International Aero Engines SERVICE BULLETIN

ENGINE - HP DISKS AND BLADES - STAGES 7 AND 8 ROTOR BLADES
WITH DAMPING WIRES AND STAGES 6, 7 AND 8 BLADES WITH
ANTI-FRET COATING

V2500-A1

72-41-00

Figure 1 (Sheet 1 of 3)

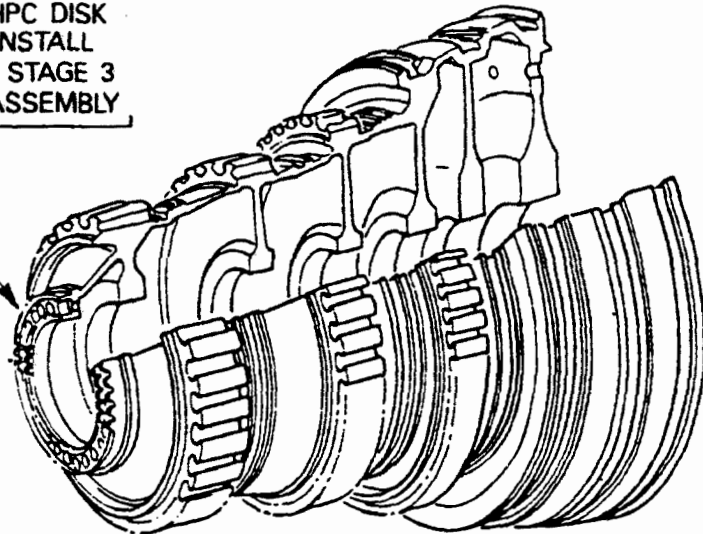
REMOVE 6A3339 STAGE 6
HPC RH LOCKING BLADES
AND INSTALL 6A5587
STAGE 6 HPC RH
LOCKING BLADES

REMOVE 6A3340
C01 AND 6A3340
C02 STAGE 6 HPC
BLADES AND INSTALL
6A5583 C01 AND
6A5583 C02 STAGE 6
HPC BLADES

REMOVE 6A3338
STAGE 6 HPC LH
LOCKING BLADES AND
INSTALL 6A5586
STAGE 6 HPC LH
LOCKING BLADES

* REMOVE THE APPLICABLE
STAGES 3 TO 8 HPC DISK
ASSEMBLY AND INSTALL
THE APPLICABLE STAGE 3
TO 8 HPC DISK ASSEMBLY

Figure 1 (Sheet 2 of 3)

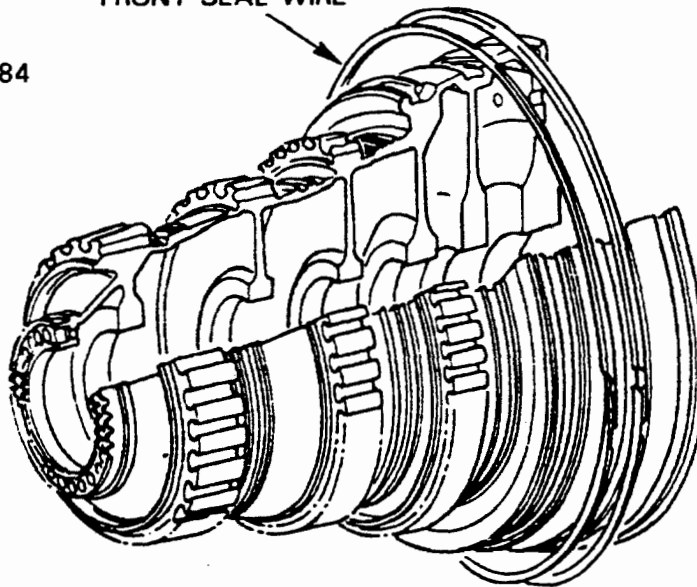
REMOVE 6A3247 STAGE 7
HPC RH LOCKING BLADES
AND INSTALL 6A5589
STAGE 7 HPC RH
LOCKING BLADES

REMOVE 6A3245 C01 AND
6A3245 C02 STAGE 7 HPC
BLADES AND INSTALL 6A5584
C01 AND 6A5584 C02
STAGE 7 HPC BLADES

REMOVE 6A3246 STAGE 7
HPC LH LOCKING BLADES
AND INSTALL 6A5588
STAGE 7 HPC LH
LOCKING BLADES

INSTALL 6A4915 STAGE 7
FRONT SEAL WIRE

INSTALL 6A4916 STAGE 7
REAR SEAL WIRE

Figure 1 (Sheet 3 of 3)

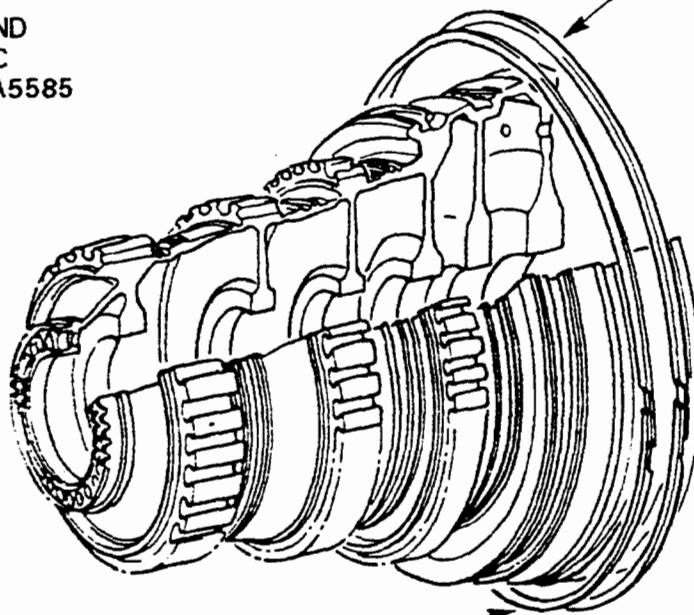
REMOVE 6A3250 STAGE 8 HPC
RH LOCKING BLADES AND
INSTALL 6A5591 STAGE 8 HPC
RH LOCKING BLADES

REMOVE 6A3249 STAGE 8
HPC LH LOCKING BLADES
AND INSTALL 6A5590
STAGE 8 HPC LH LOCKING
BLADES

INSTALL 6A4918 STAGE 8
REAR SEAL WIRE

REMOVE 6A3248 C01 AND
6A3248C02 STAGE 8 HPC
BLADES AND INSTALL 6A5585
C01 AND 6A5585 C02
STAGE 8 HPC BLADES

INSTALL 6A4917 STAGE 8
FRONT SEAL WIRE

General section thru HP compressor
- Before and after alteration
Figure 2

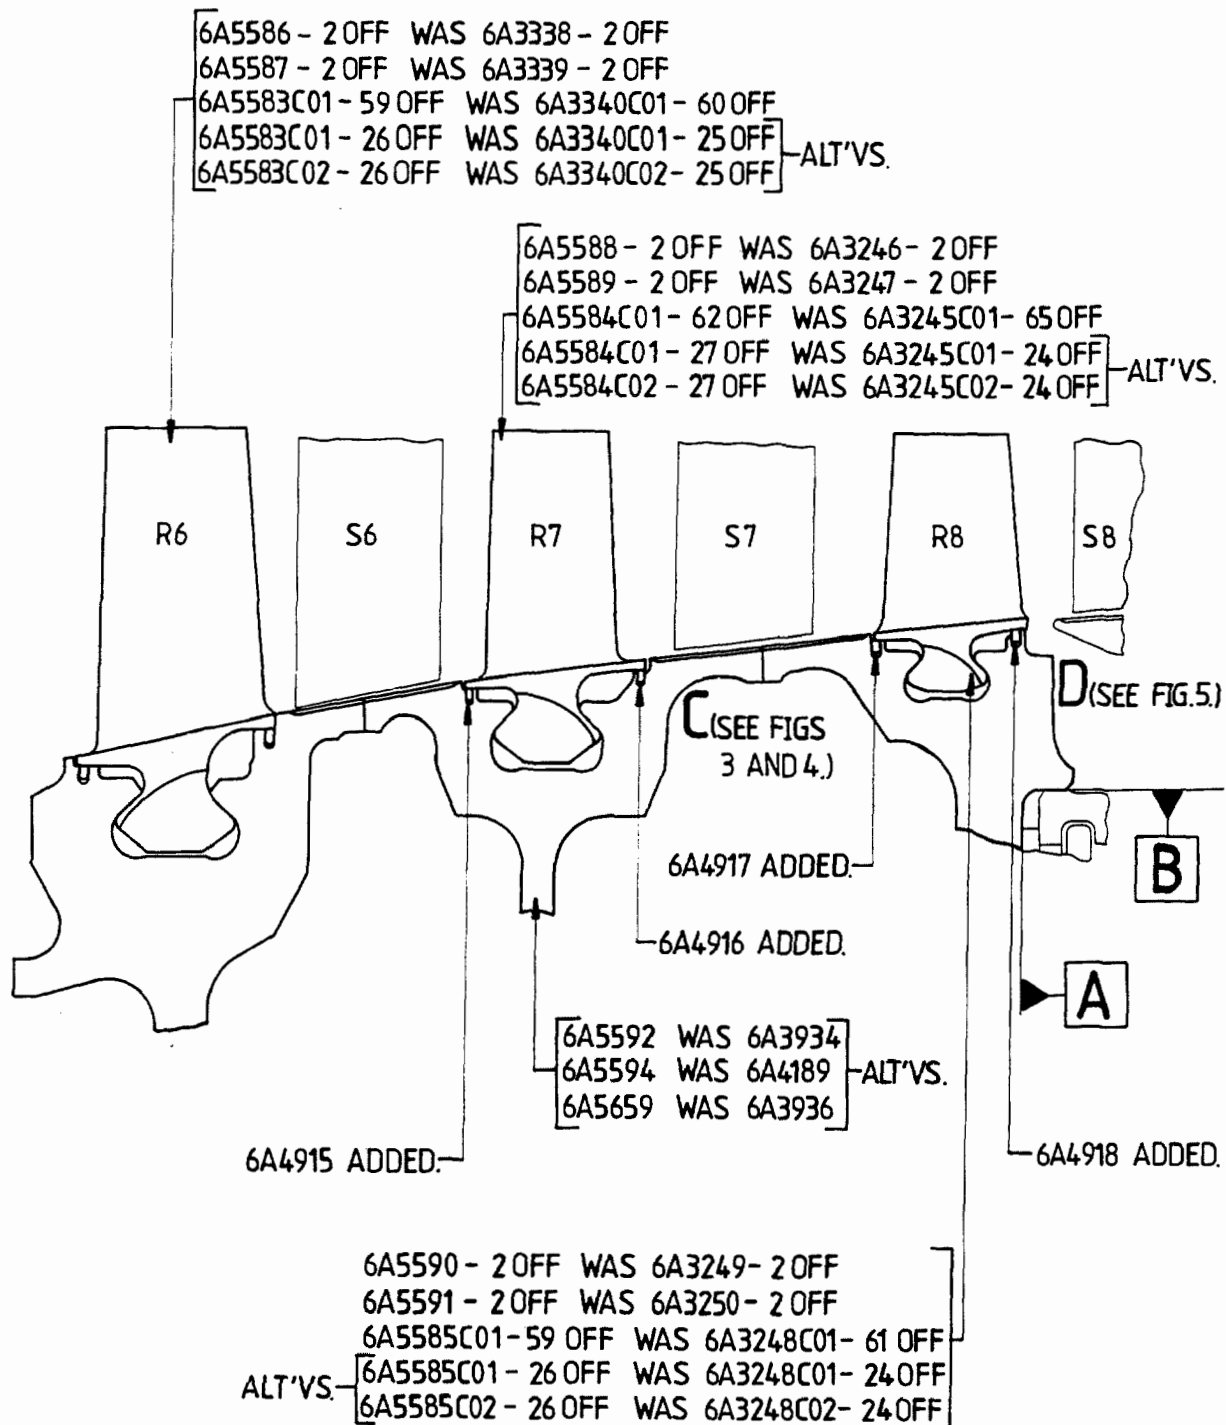
This Service Bulletin introduces H.P. compressor stages 6,7 and 8 rotor blades with a PL 239 anti-fretage coating on the dovetail flanks and a stage 3 to 8 disk assembly with stages 7 and 8 damping wires. Existing blades can be reworked by applying the anti-fretage coating to the dovetail root flanks.

Existing stage 3 to 8 disk assemblies can be reworked by machining grooves to house the damping wires.

R Existing Stage 3 to 12 disk assemblies, rear shaft and seal assembly can be reworked by machining grooves to house the damping wires.

HP compressor rotor assembly
Figure 2A

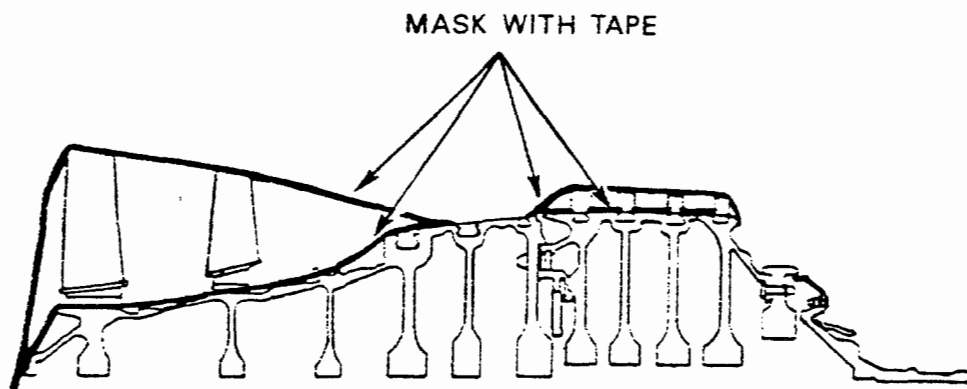
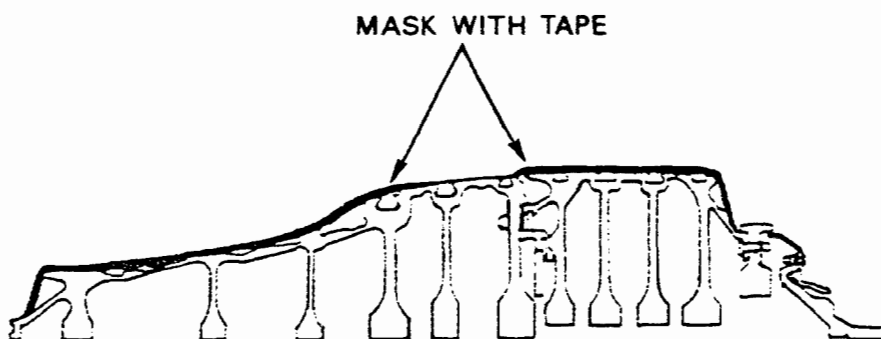
Use CoMat 02-005. Make sure
that cutting and cleaning fluids
cannot penetrate the masking.
Refer to Figure 2A.

Install the HP compressor rotor assembly for stage 7 and 8 slot machining
Figure 2B

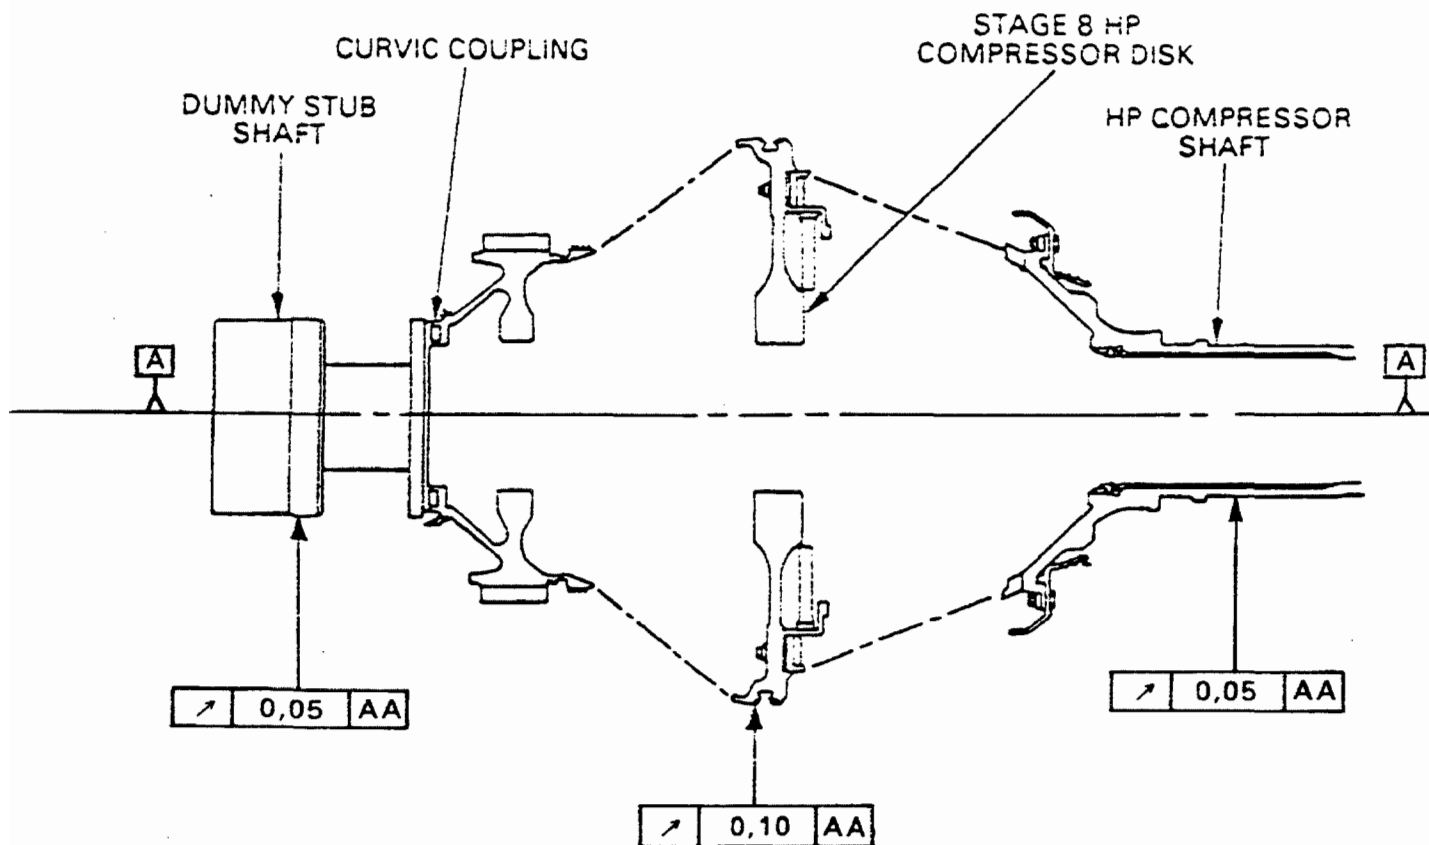
Use standard workshop tools with
centre lathe. Use dial test
indicator to make sure HP
compressor arrangement runs
true.
Refer to Figure 2B.

Reworking of existing compressor shaft
assembly (stage 7)
Figure 3

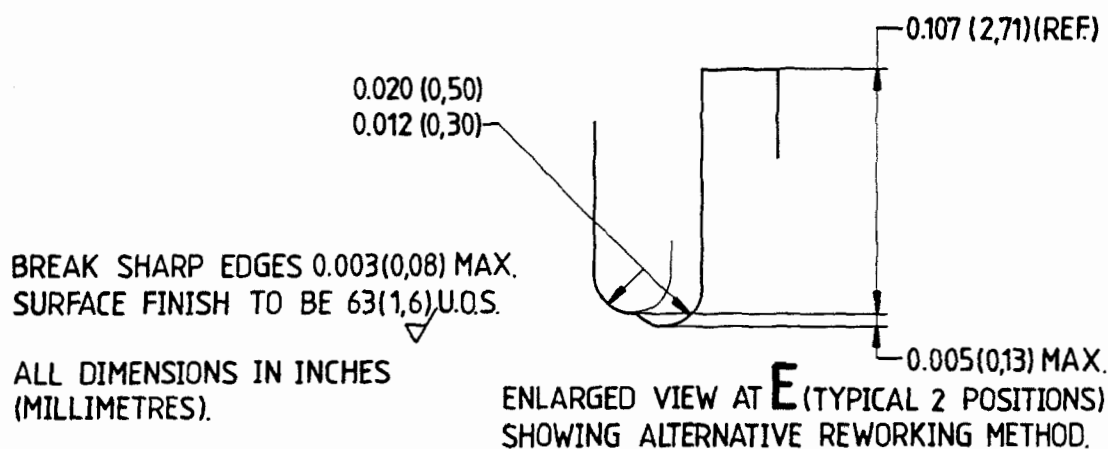
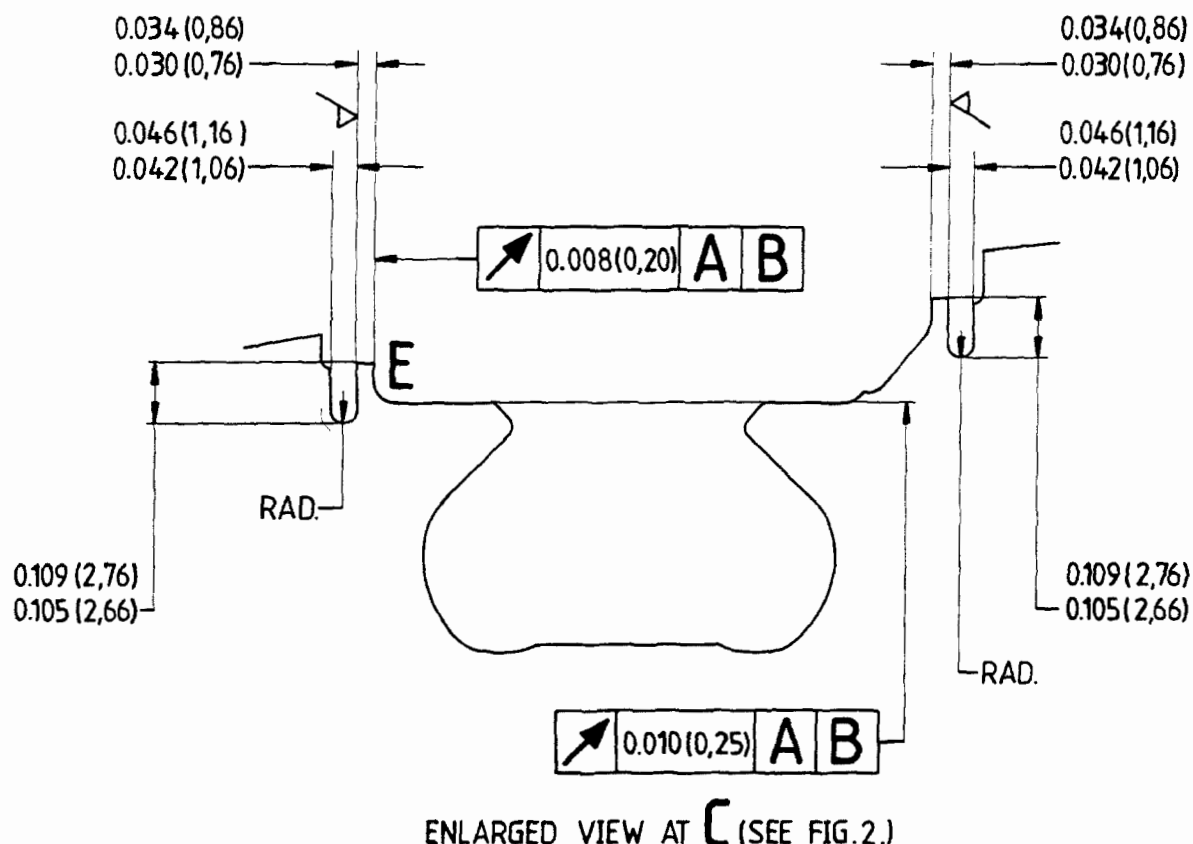
Use IAE 3R19100 front groove tool, 1 off.
Refer to Figures 2,3 and 5

Use IAE 3R19079 front groove tool, 1 off, and IAE 3R19080 rear groove tool, 1 off, as applicable.
Refer to Figures 2,3 and 5

Reworking of existing compressor shaft
assembly (stage 7)
Figure 4

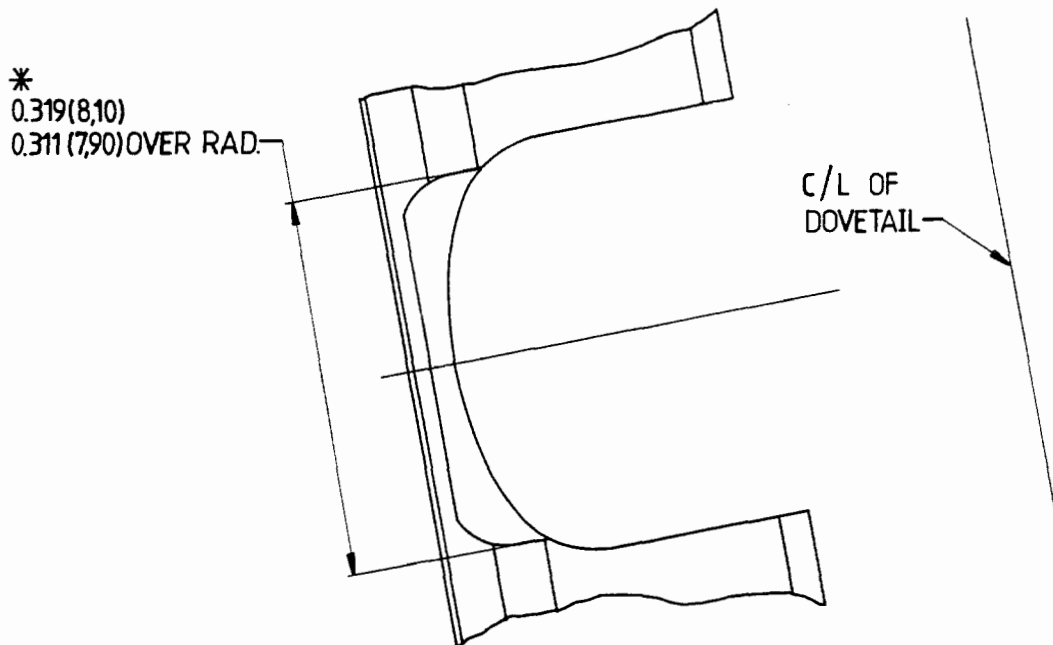
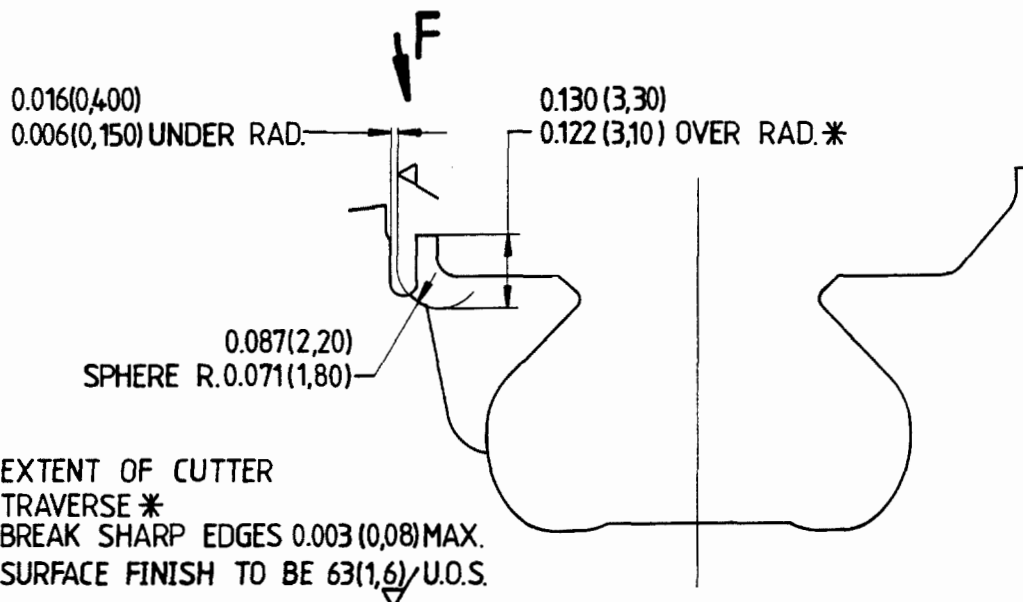
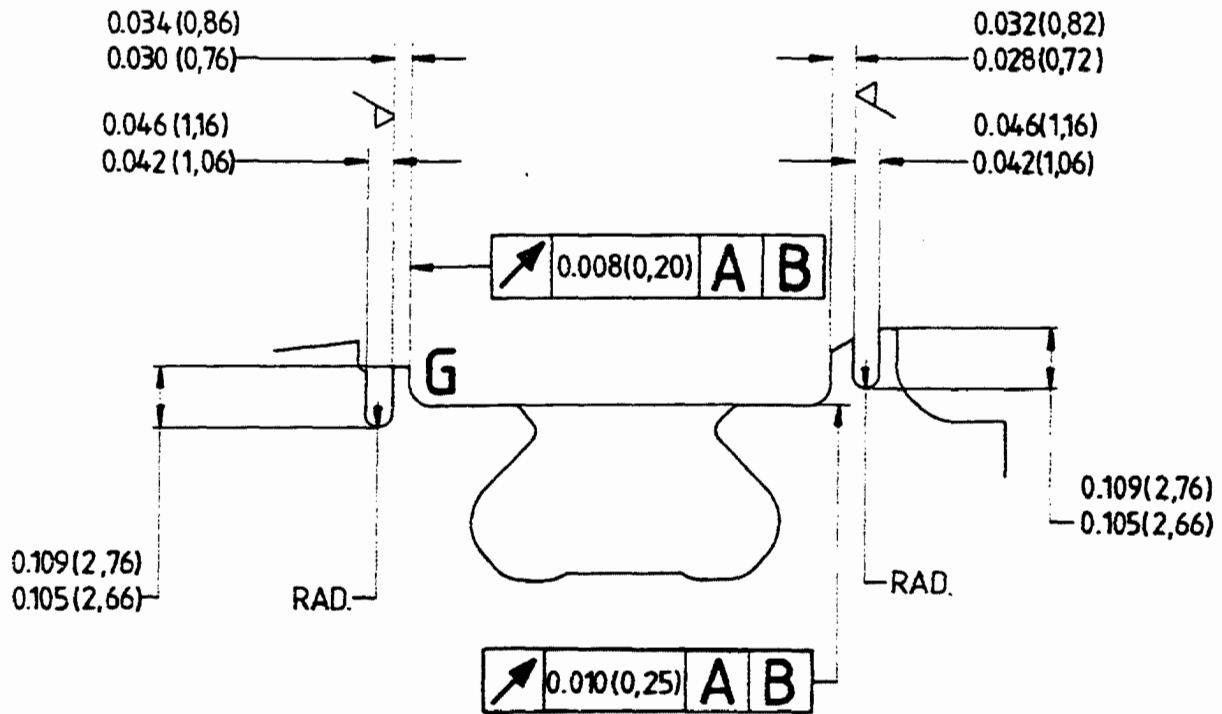
See Figures 3 and 4

EXTENT OF CUTTER
TRAVERSE *
BREAK SHARP EDGES 0.003(0,08) MAX.
SURFACE FINISH TO BE 63(1,6)/U.O.S.

REPEAT ENLARGED VIEW AT C (SEE FIG.2.)
SHOWING MACHINING REQUIRED AT LOADING SLOT.

Reworking of existing compressor shaft
assembly (stage 8)
Figure 5

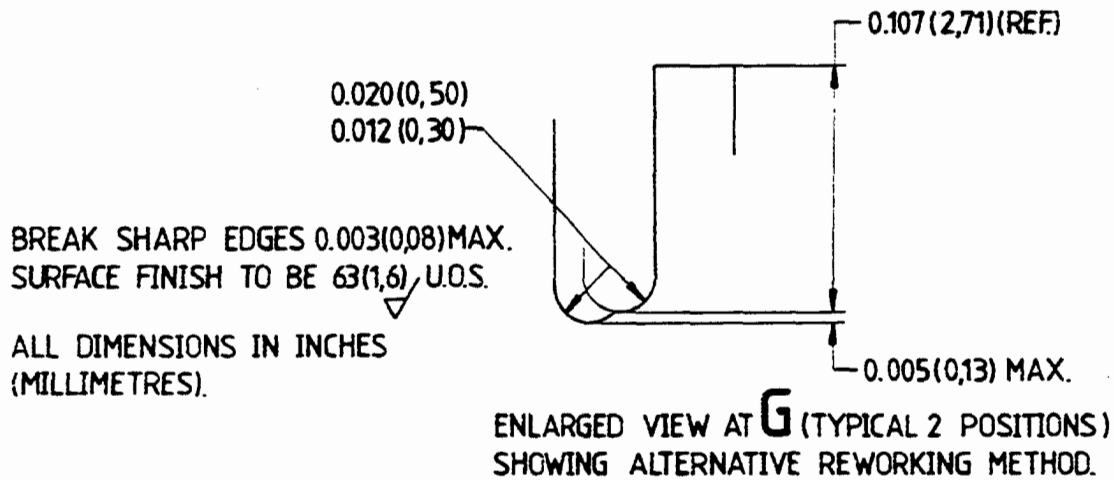
Flat surface required to avoid deflection/breakage of fine groove tool during machining. Use standard turning tool. Refer to Figures 2 and 5

ENLARGED VIEW AT G (TYPICAL 2 POSITIONS)
SHOWING ALTERNATIVE REWORKING METHOD.

Figure 6 Sheet 1 of 2

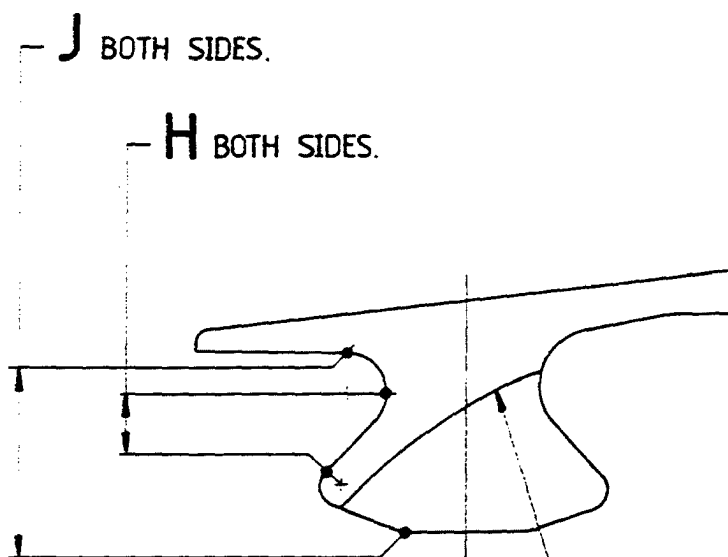
- (h) Apply the dry film lubricant to a thickness of between 0.0003in. (0,008 mm) and 0.0012in. (0,030 mm)
- (i) Stove the components
- (j) Examine the dry film lubricant

COAT AREAS MARKED **H** IN ACCORDANCE WITH
ACCOMPLISHMENT INSTRUCTIONS (0.0003 (0,008) TO
0.0012 (0,030) THICK.)
OVERSPRAY IS PERMISSIBLE ON ADJACENT SURFACES
WITHIN AREAS MARKED **J**.

OVERSPRAY ONLY IS
PERMISSIBLE ON THIS EDGE.
TYPICAL BOTH SIDES.

Figure 6 Sheet 2 of 2

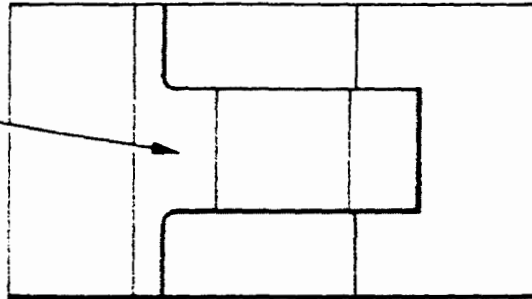
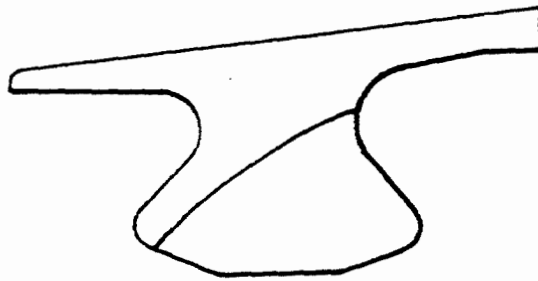
- R (ii) This procedure is alternative to step (k)(i). It is permissible to re-identify the blade by adding the symbol as shown in Figure 6. Do not delete the existing part number if you use this procedure

IF ALTERNATIVE METHOD
OF BLADE IDENTIFICATION
IS CHOSEN, ENGRAVE
THE SYMBOL ☐ HERE
